Lindon City Planning Commission Staff Report

Item 4: Conditional Use Review of Single-Family Home Addition in the Hillside Protection District — 62 S Denali Circle

Project Address: 62 S. Denali Circle

SITE PLAN

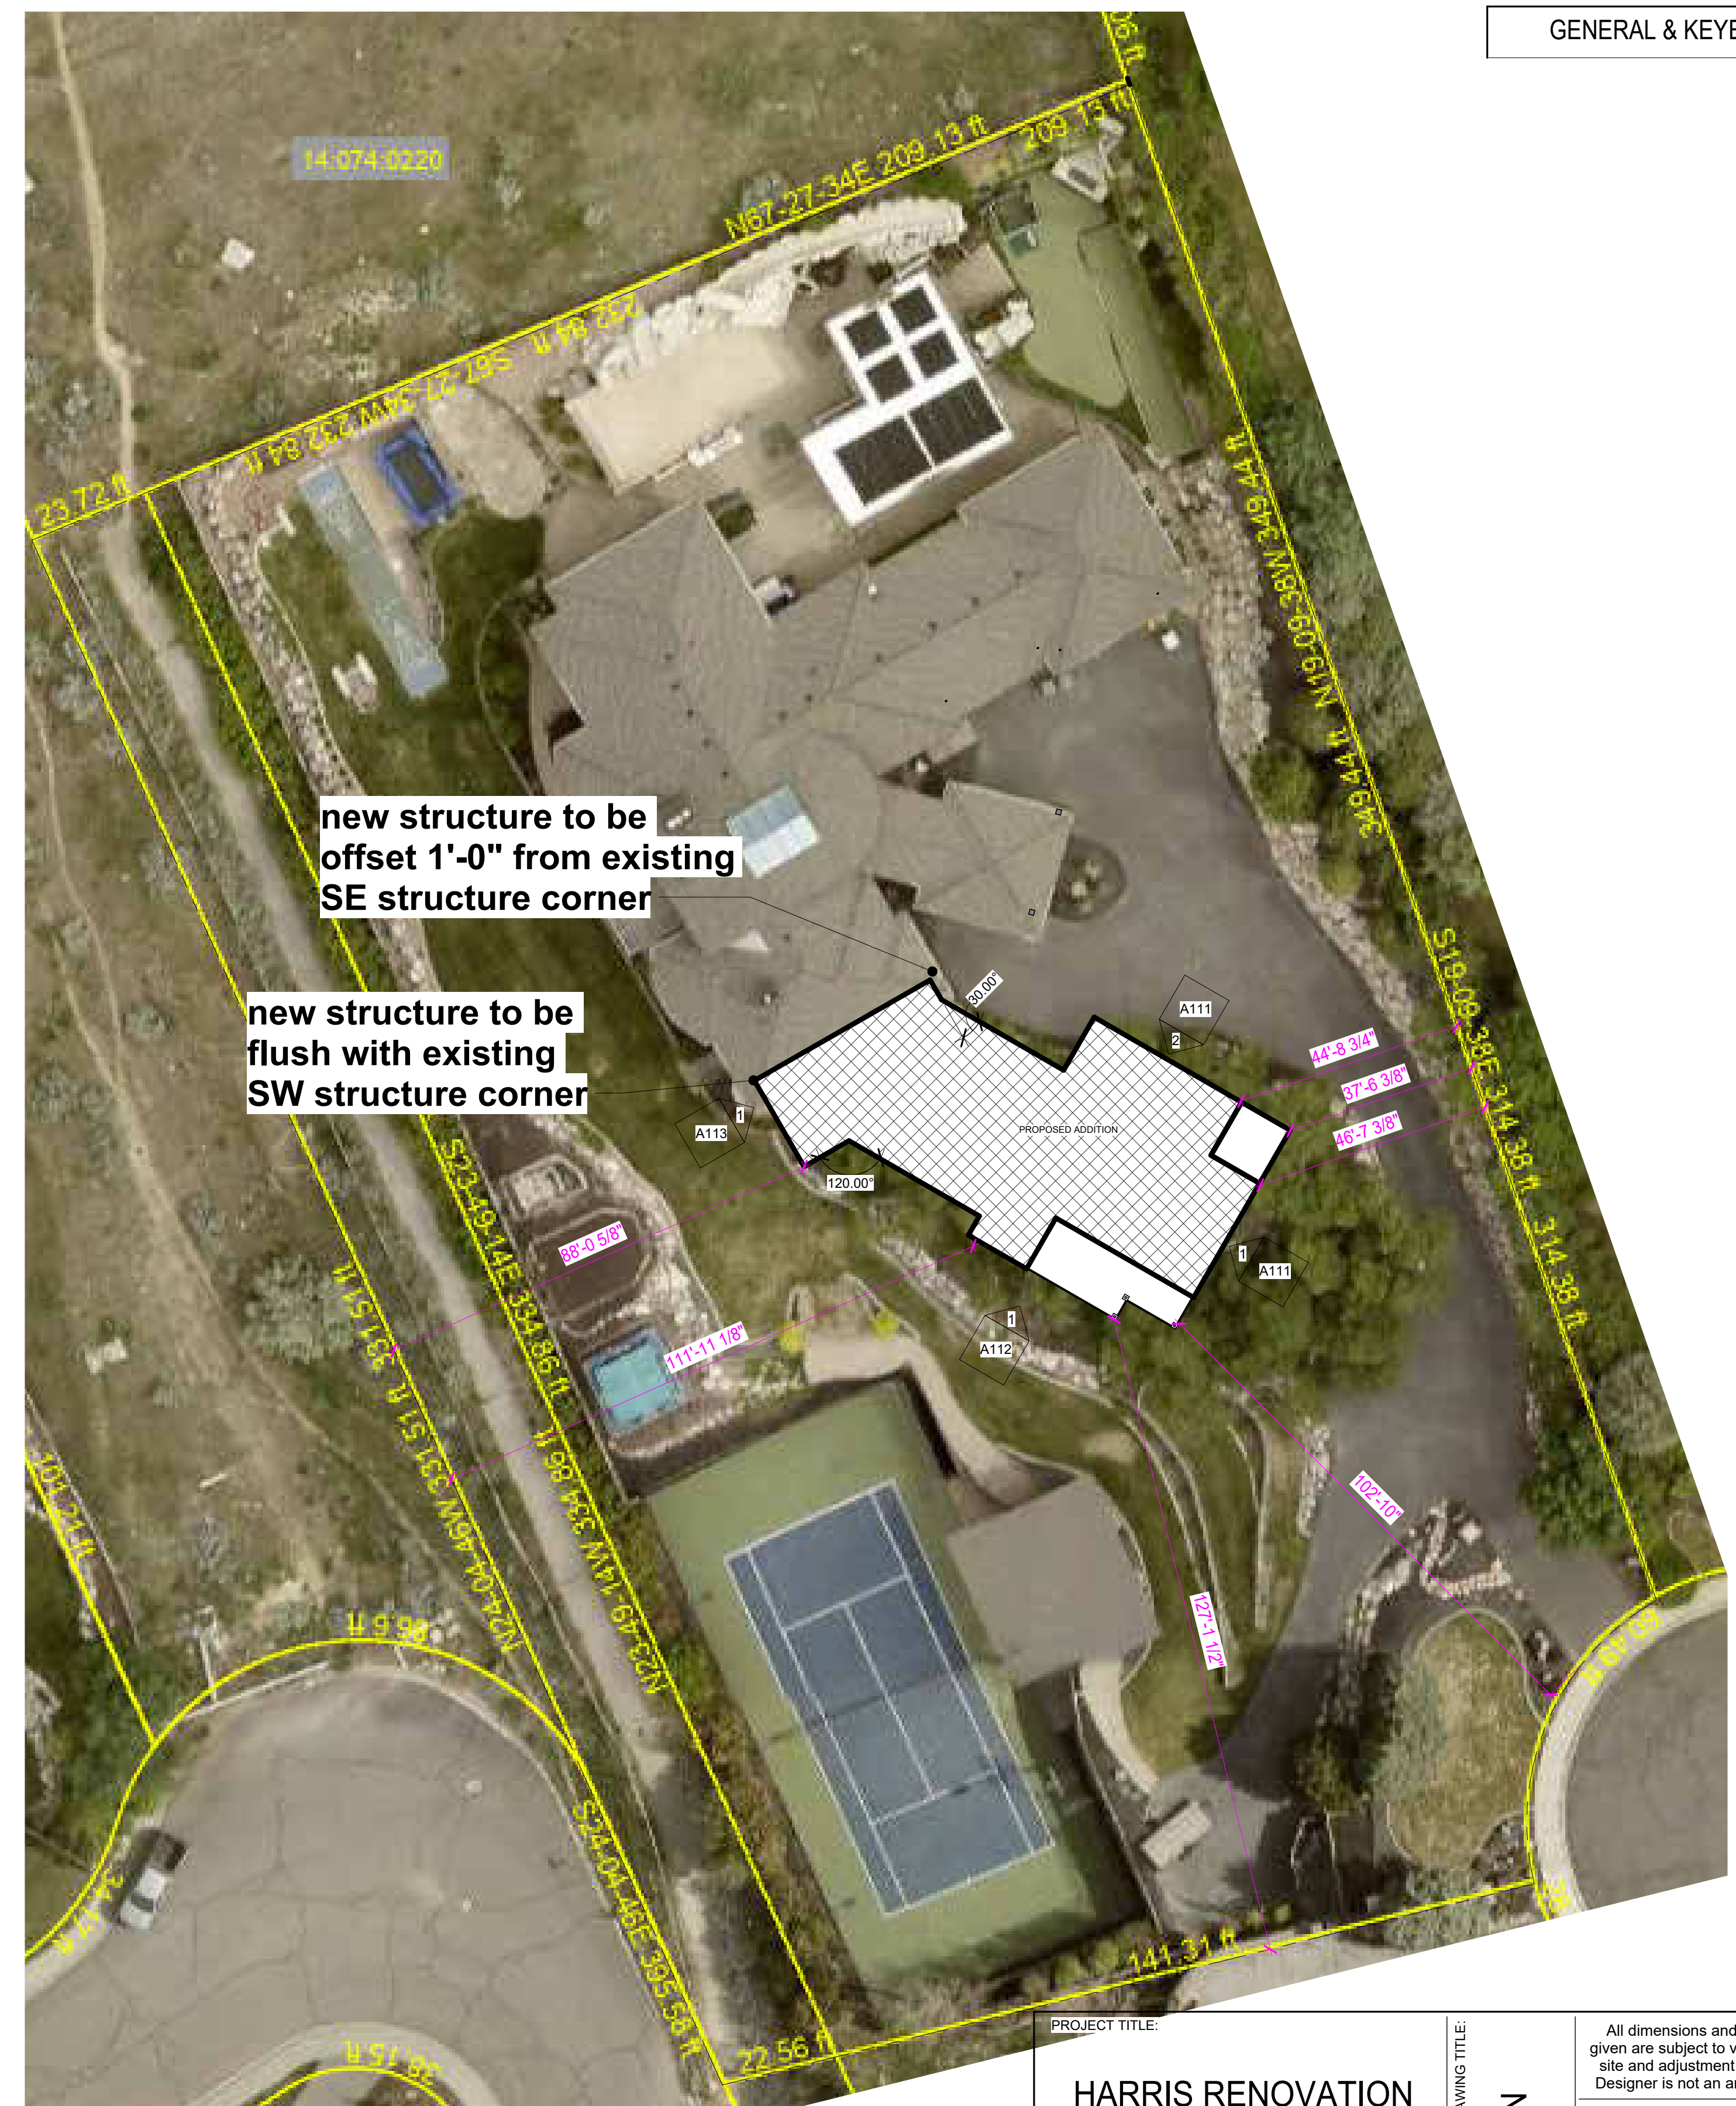
Building Site Requirements	Proposal	Compliant
Each lot or parcel of land shall contain a primary building site appropriate to accommodate the primary residential structure, which building site shall be outlined on the subdivision plat. The primary building site shall include a buildable area of sufficient size to allow not less than two thousand five hundred (2,500) square feet of footprint for the residential structure, after allowing for all required setbacks, and other requirements.	The Canberra Heights Plat A identifies the buildable area on the plat. The home will have a footprint exceeding 2,500 sq ft but is located within the footprint on the plat.	Yes
Grading of the lot or parcel which is related to creation of the primary building site or construction of the structure shall not extend closer than twenty (20) feet from the lot or parcel boundary lines, nor more than thirty (30) feet, horizontally, in front, to the rear or to the side of the proposed structure unless a greater distance is approved by the planning commission upon a showing by the developer that a greater distance will not be contrary to the purpose of this chapter.	From the edge of the existing driveway to the east rear property line is approximately 20'. All other setbacks exceed the 30' requirement	Yes

The primary building site shall have a natural or manmade slope of twenty (20) percent or less.	The contractor has stated that the 20% slope will be met. This will be confirmed prior to issuing a building permit	Yes
The driveway(s) to the building site shall have a maximum slope of twelve (12) percent and shall have direct access to a public street.	Existing	Yes
